REQUEST FOR INFORMATION	DATE: July 14, 2016	NO.: RFI-201
--------------------------------	----------------------------	---------------------

Project Name:	15051-Webster University Interdisciplinary Science Building	Project No.: 15051
---------------	---	--------------------

Subject: Mockup bottom of wall conditions

1/A451

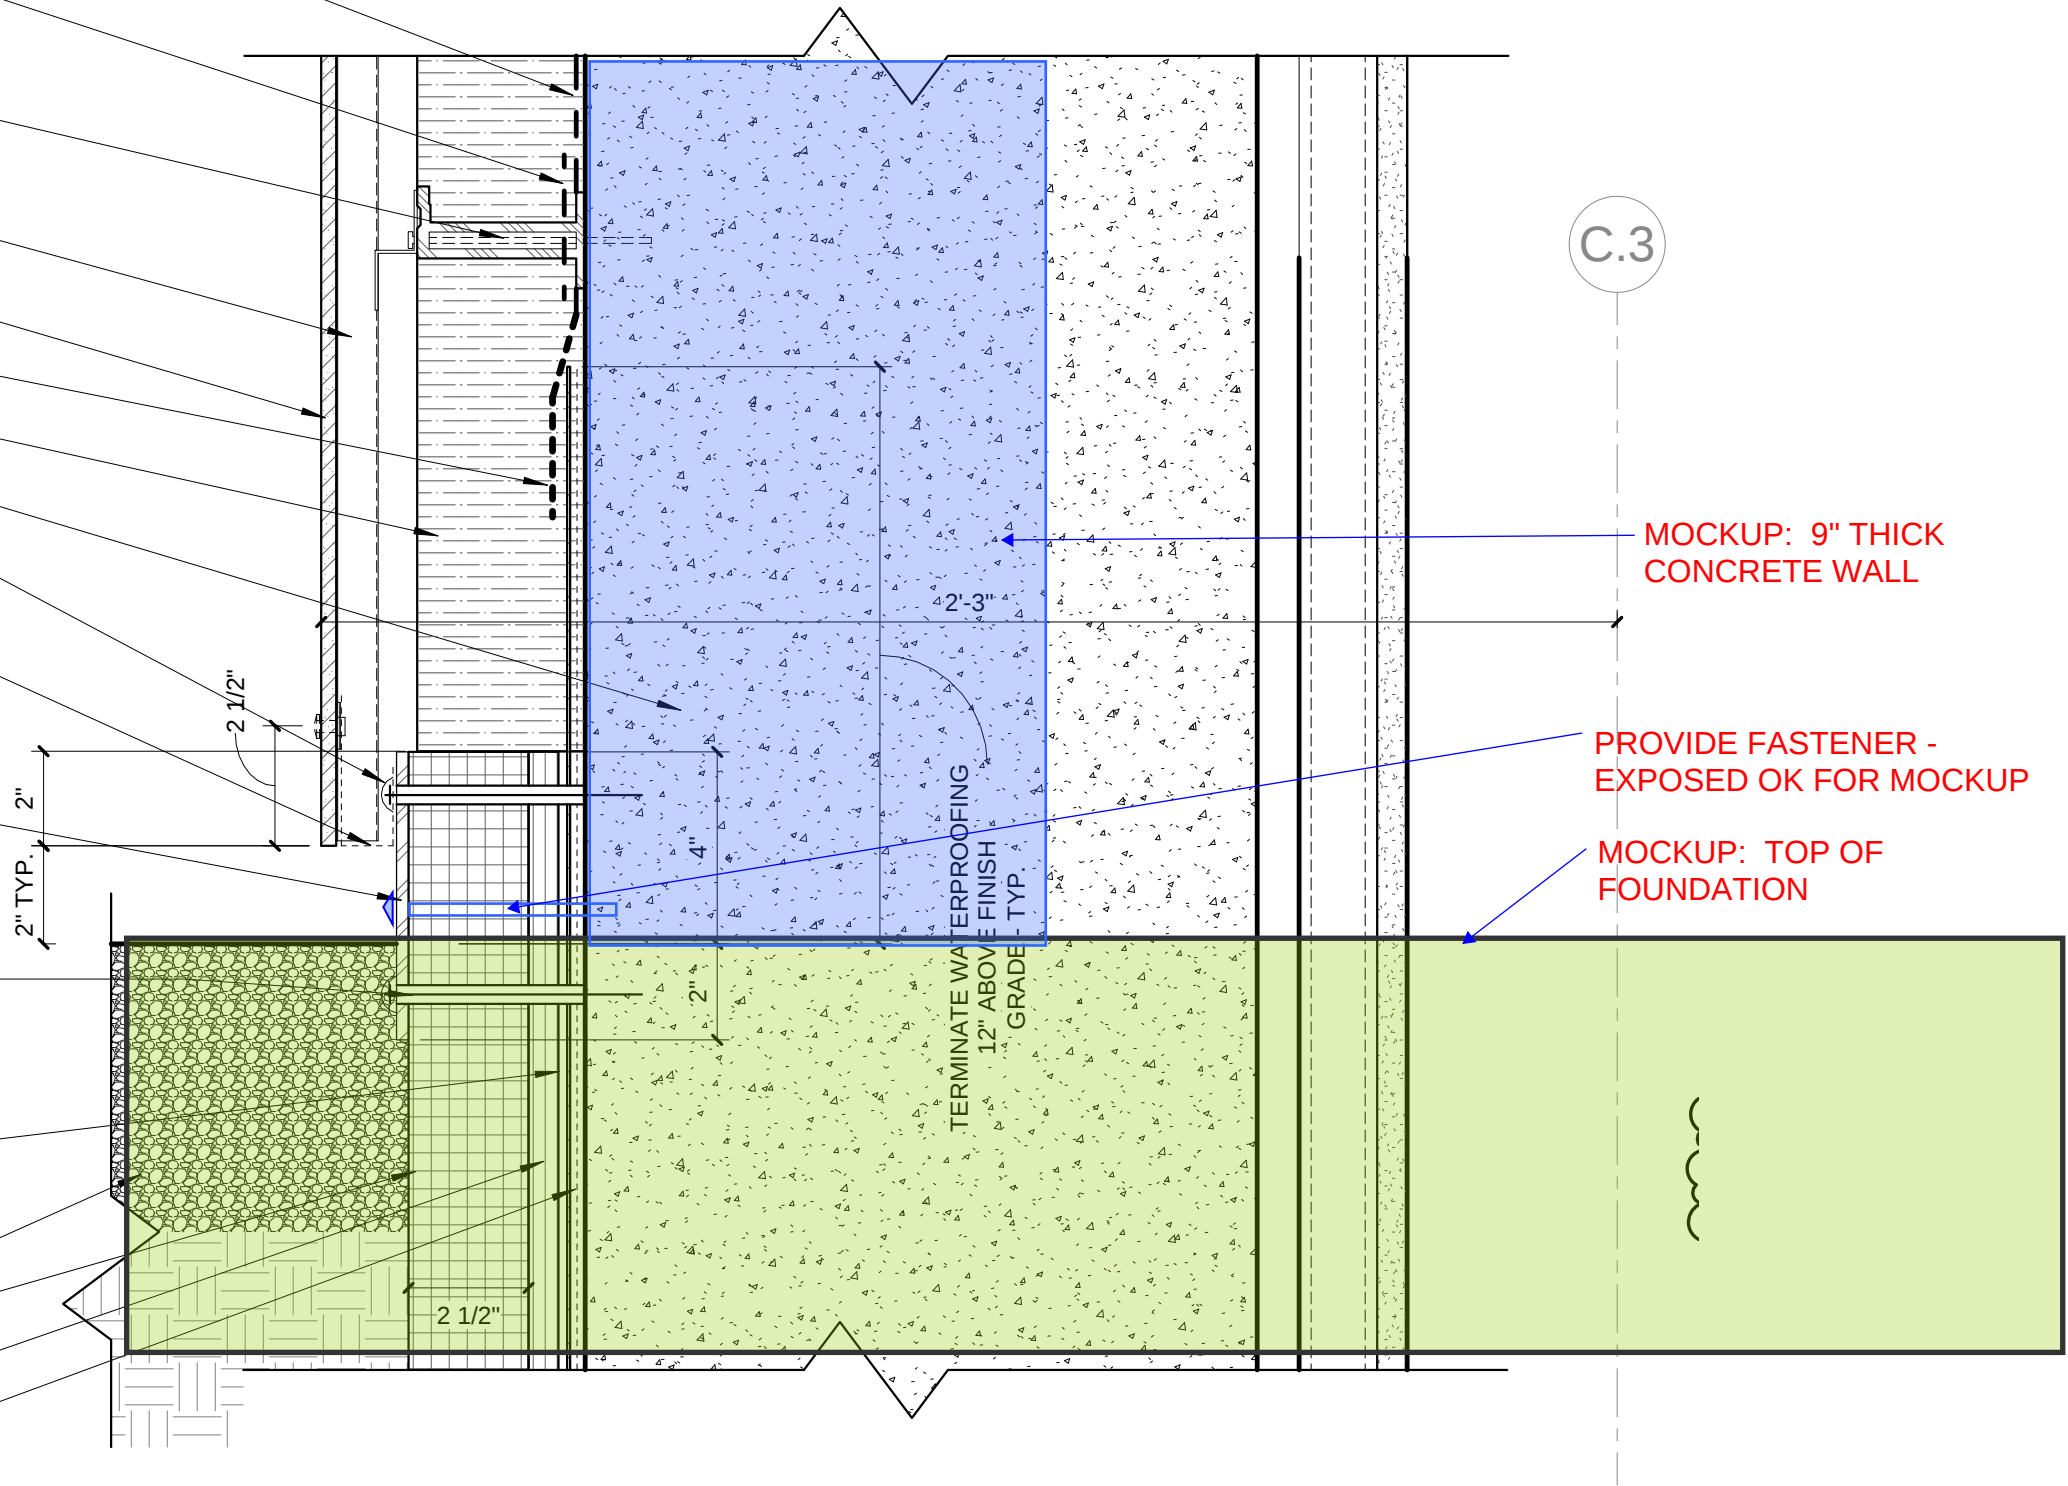
ASI#8 clarified the top of foundation to be flush with the existing pavement. Please clarify the bottom of wall conditions that need to be constructed at the mockup, and indicated the existing grade level on details 2/A451, 1/A455, and 1/A452.

IS RED LINE TO
REPRESENT TOP
OF FOUNDATION
(TOP OF
PARKING LOT)

SHOULD THE
BELOW GRADE
FASTENER BE
INSTALLED
ABOVE GRADE
ON MOCKUP?

PROVIDE 9" WIDE
WALL THIS
LOCATION PER
MOCKUP
FOUNDATION
DRAWINGS

NO - FOUNDATION 2'+/- BELOW
PER MOCKUP DRAWING A0490

THIS DETAIL TO OCCUR AT 2' ABOVE GRADE ON MOCKUP.
FOR DETAIL AT TOP OF FOUNDATION SEE FOLLOWING PAGE - 2/A0451

1/A452

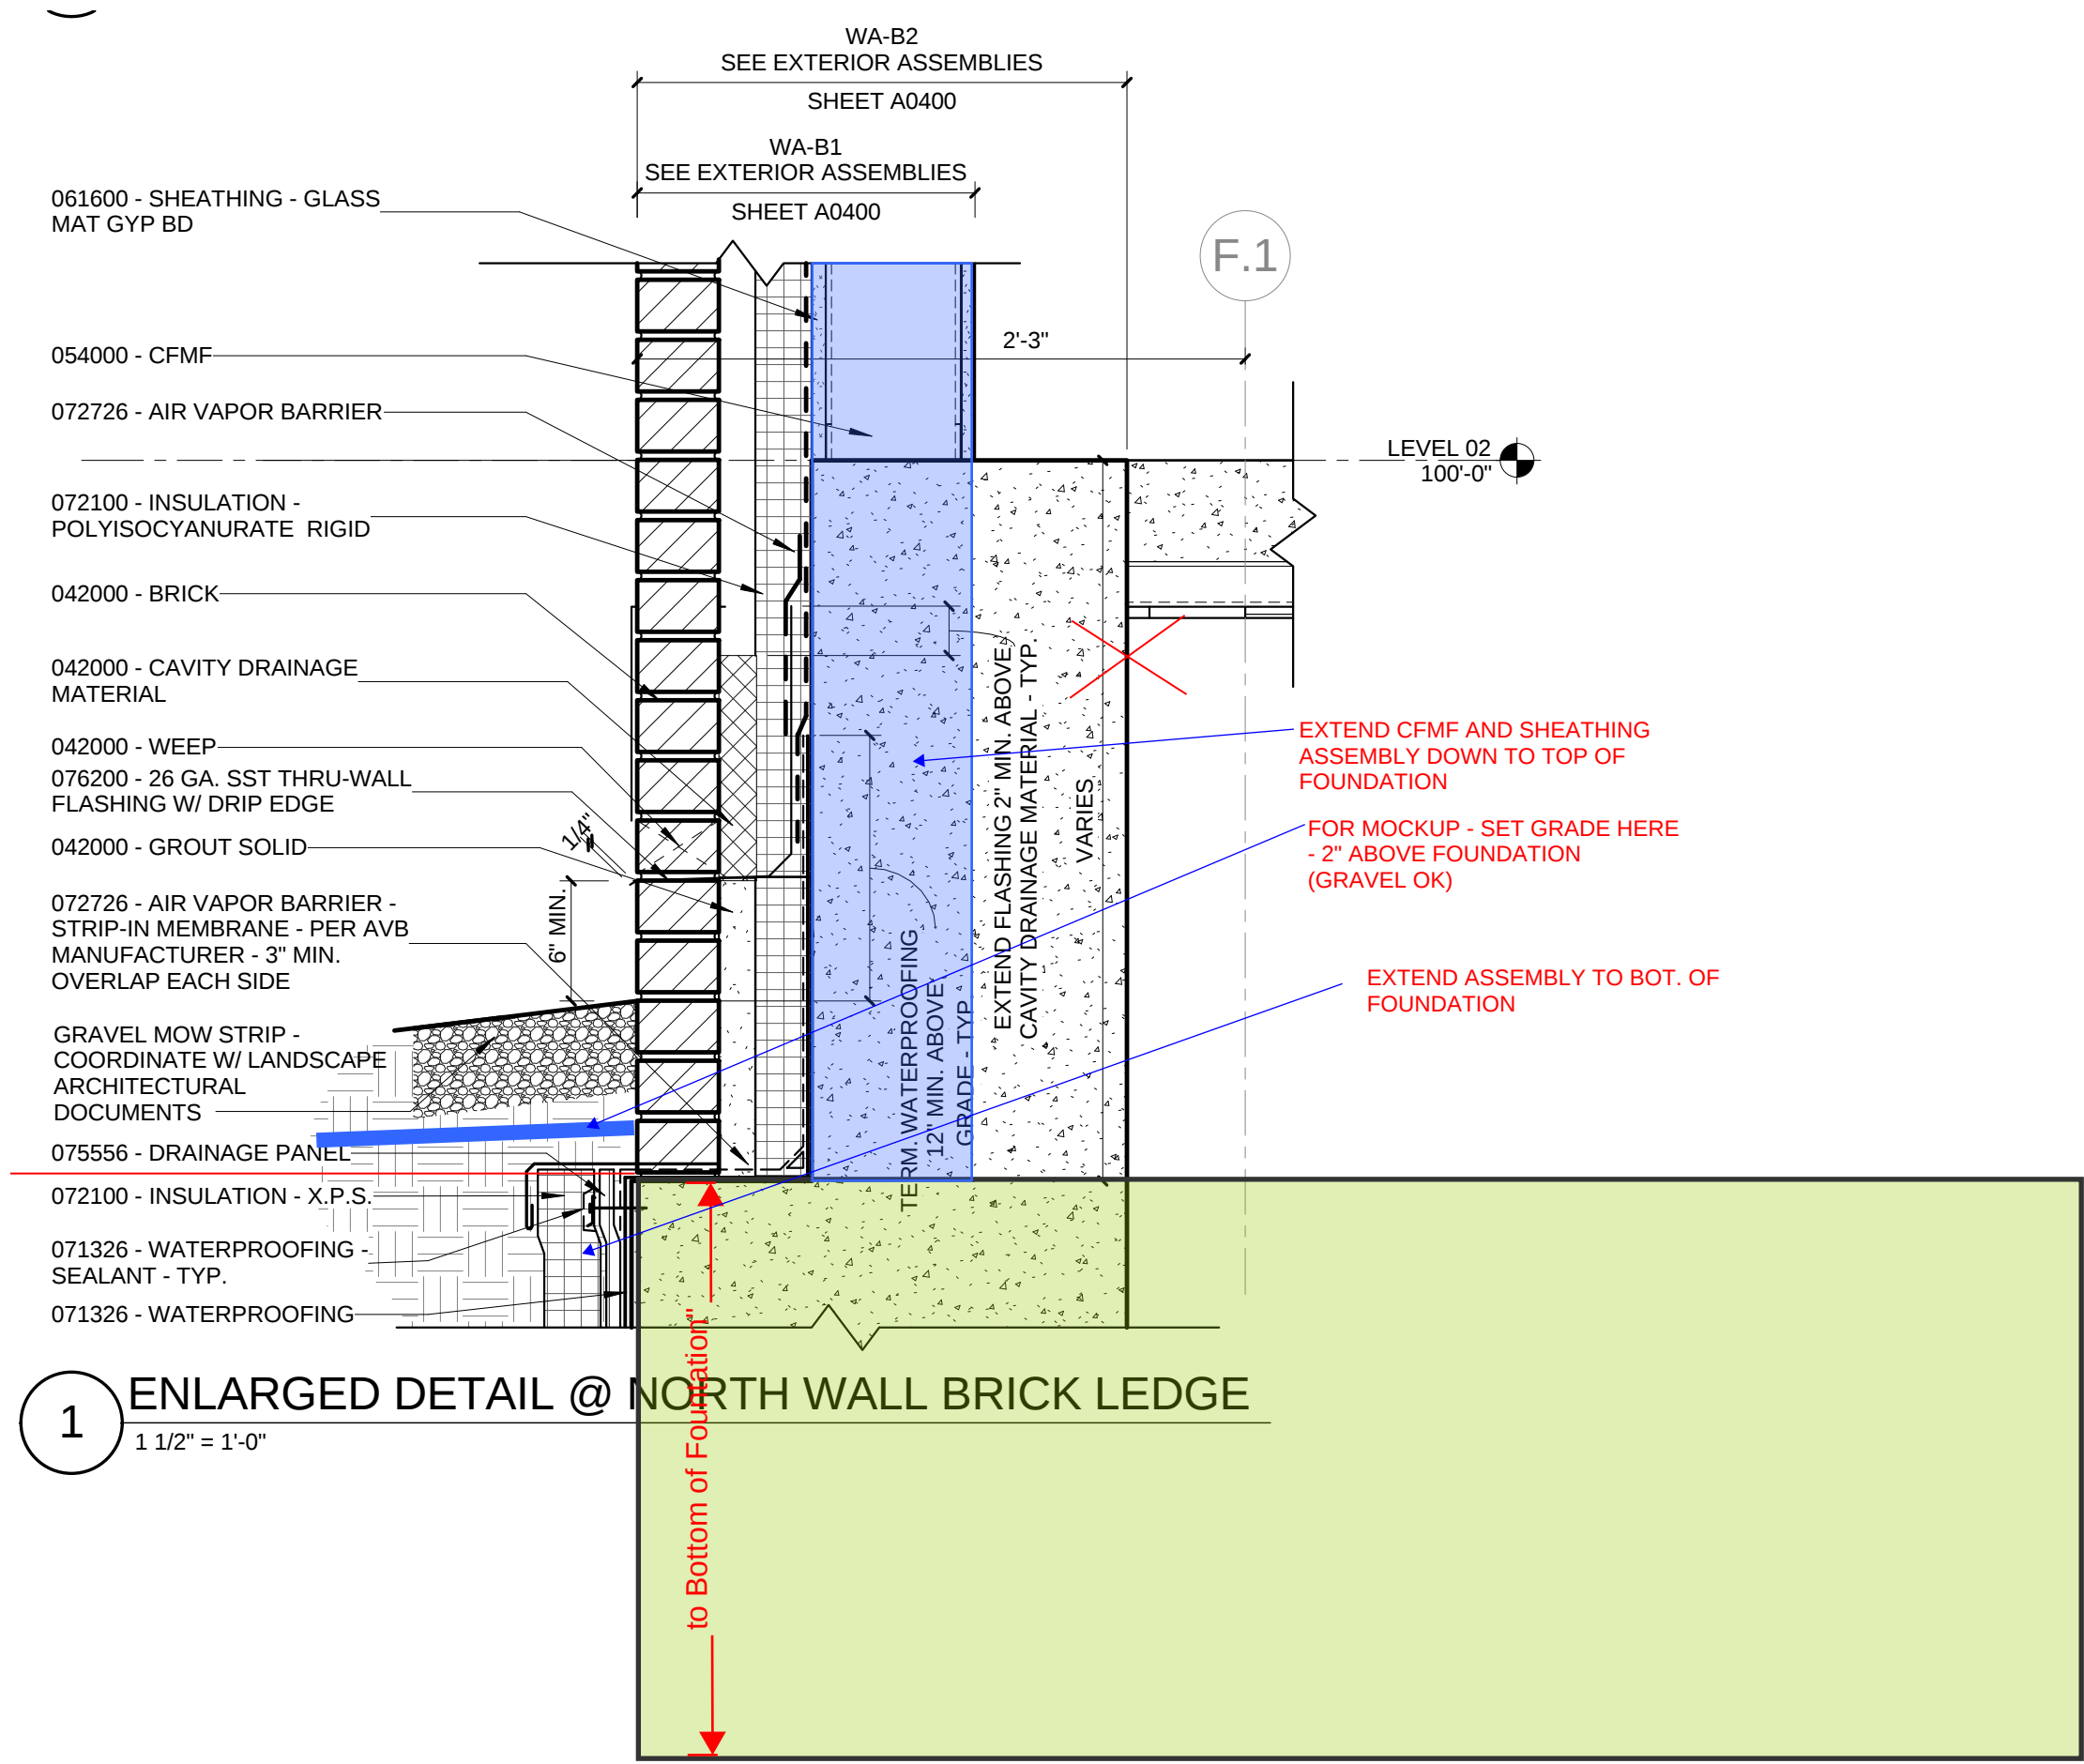
ARE WE TO
EXCLUDE
DRAINAGE PANEL,
XPS, AND
WATERPROOFING
BELOW TOP OF
PARKING LOT
FROM MOCKUP?

IS RED LINE TO
REPRESENT TOP
OF FOOTING
(TOP OF
PARKING LOT)

YES - SEE
FOLLOWING
DRAWING

SEE DRAWING FOLLOWING

SEE DRAWING FOLLOWING

1/A455

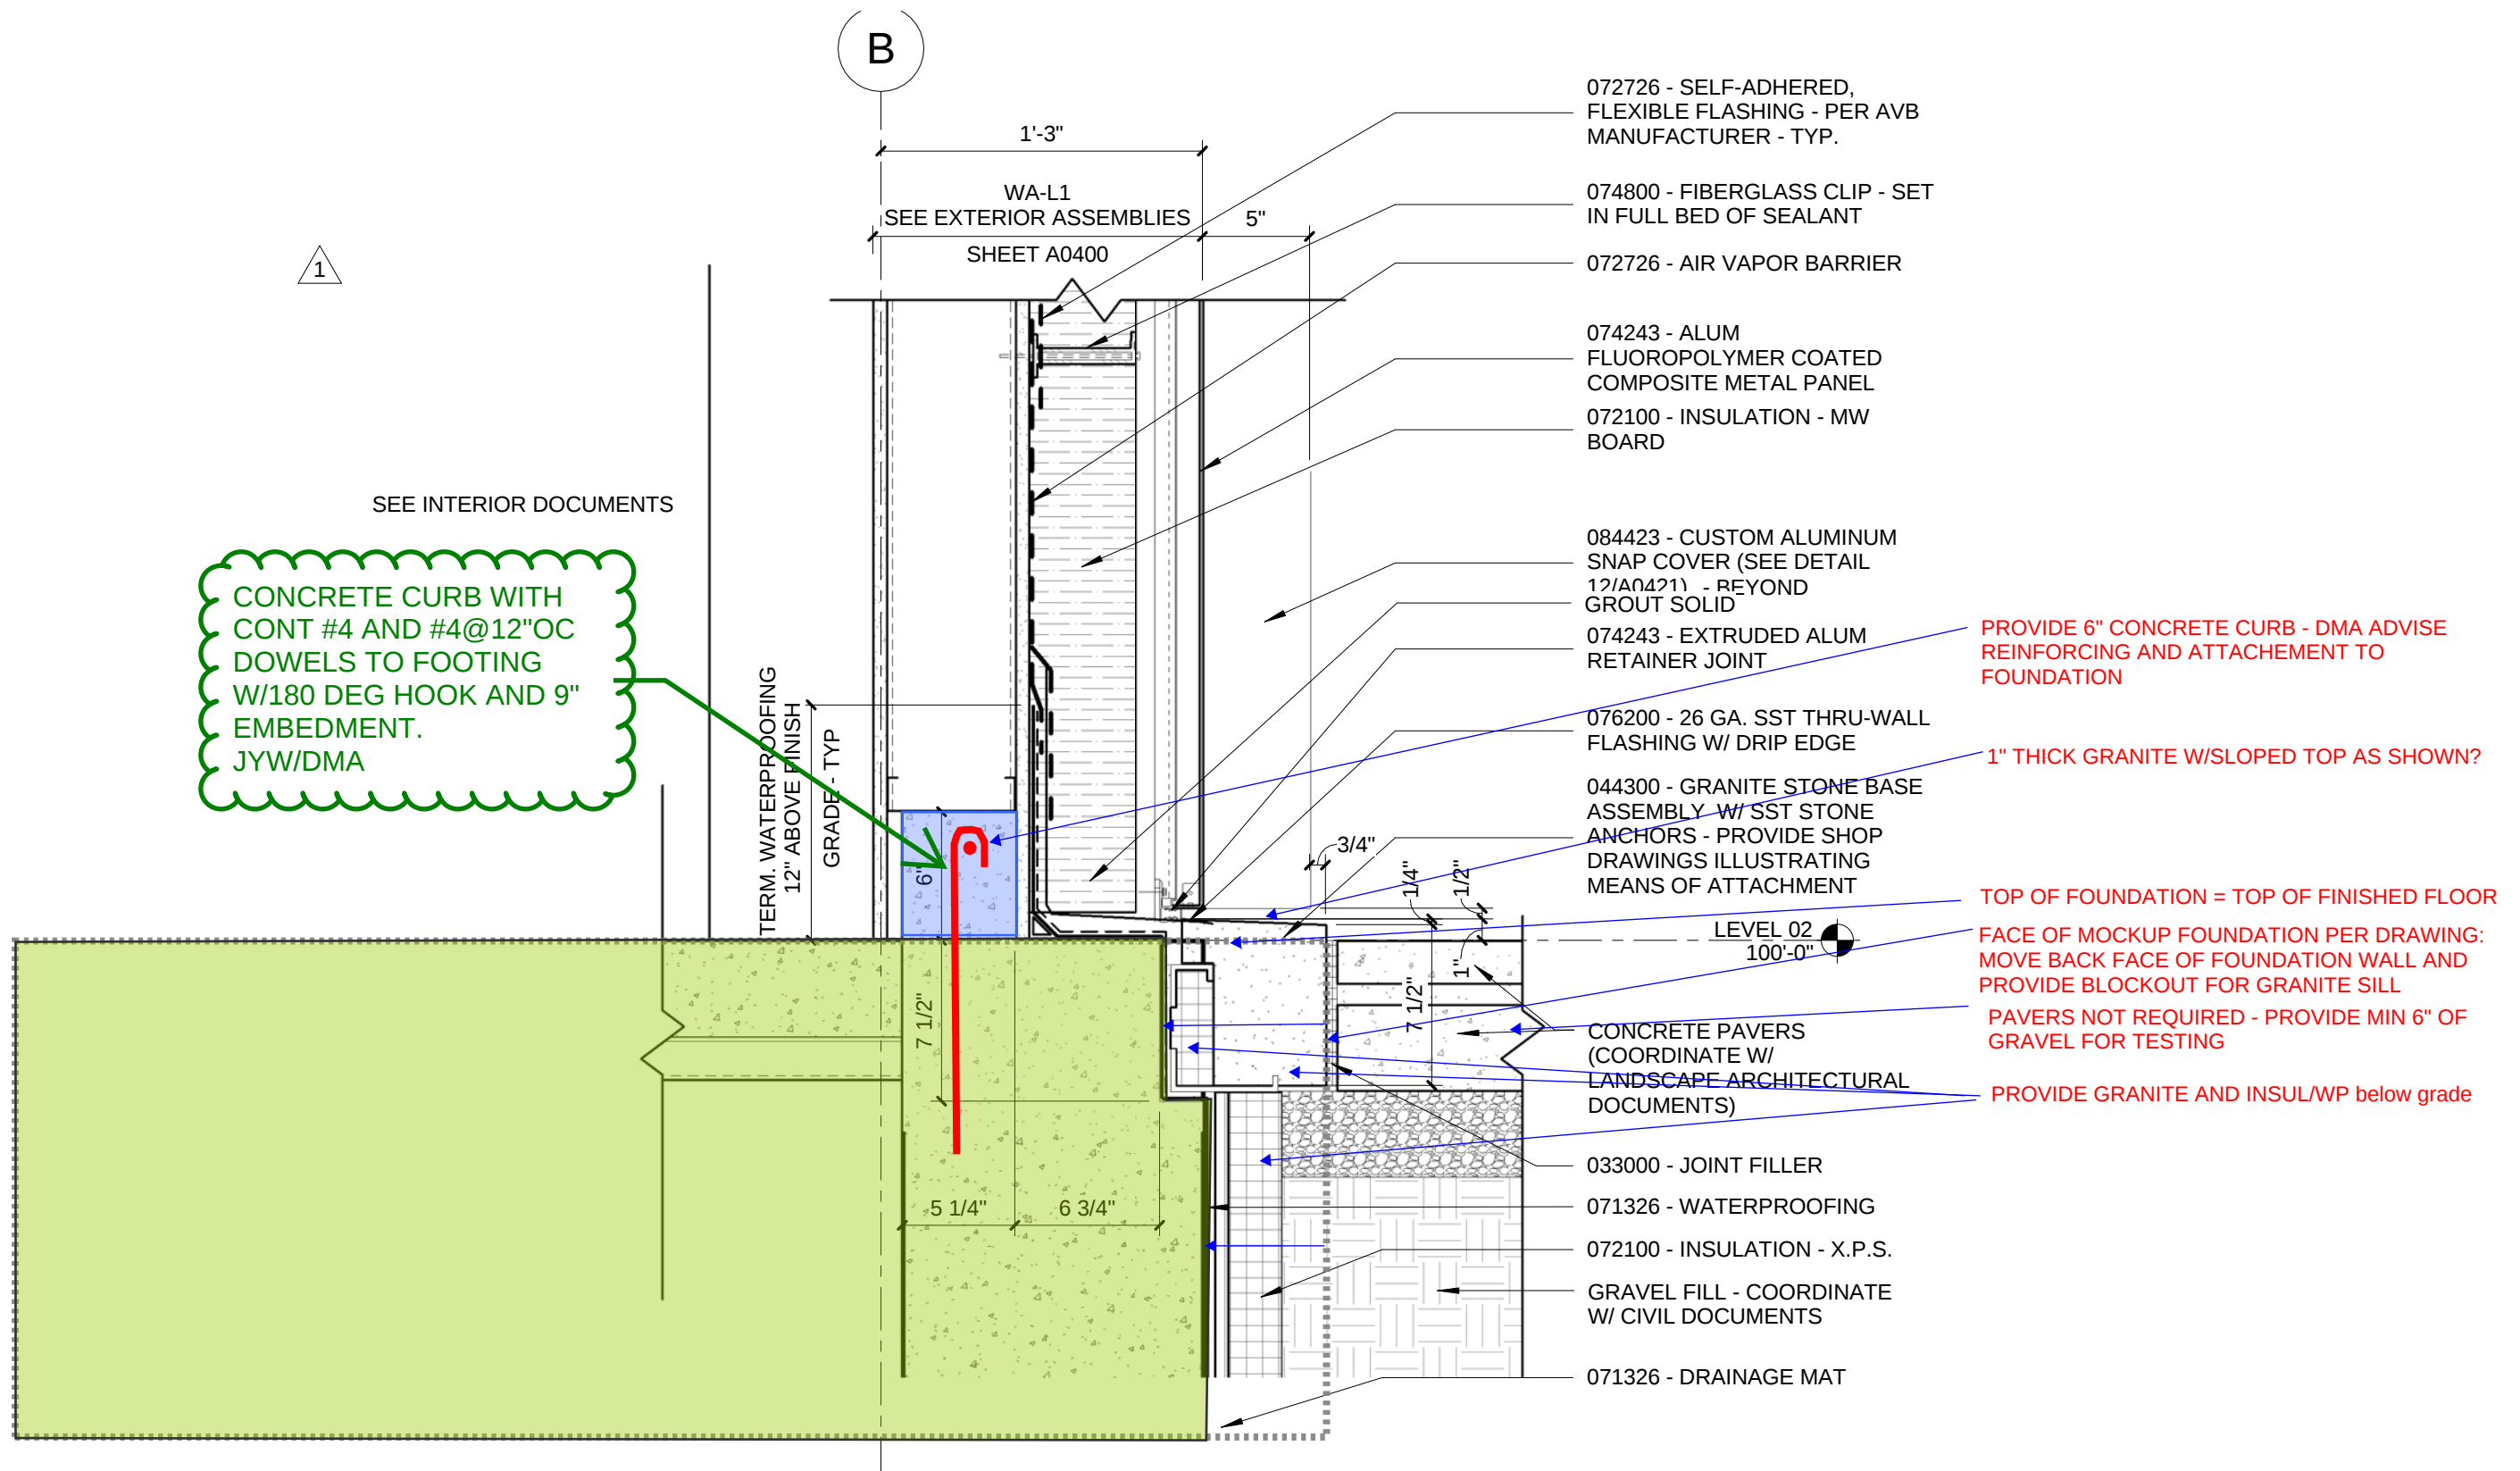
IS RED LINE TO REPRESENT TOP OF FOUNDATION (TOP OF PARKING LOT)

EXCLUDE GRANIT STONE BASE?

SEE DRAWING FOLLOWING

SEE DRAWING FOLLOWING

SEE DRAWING FOLLOWING
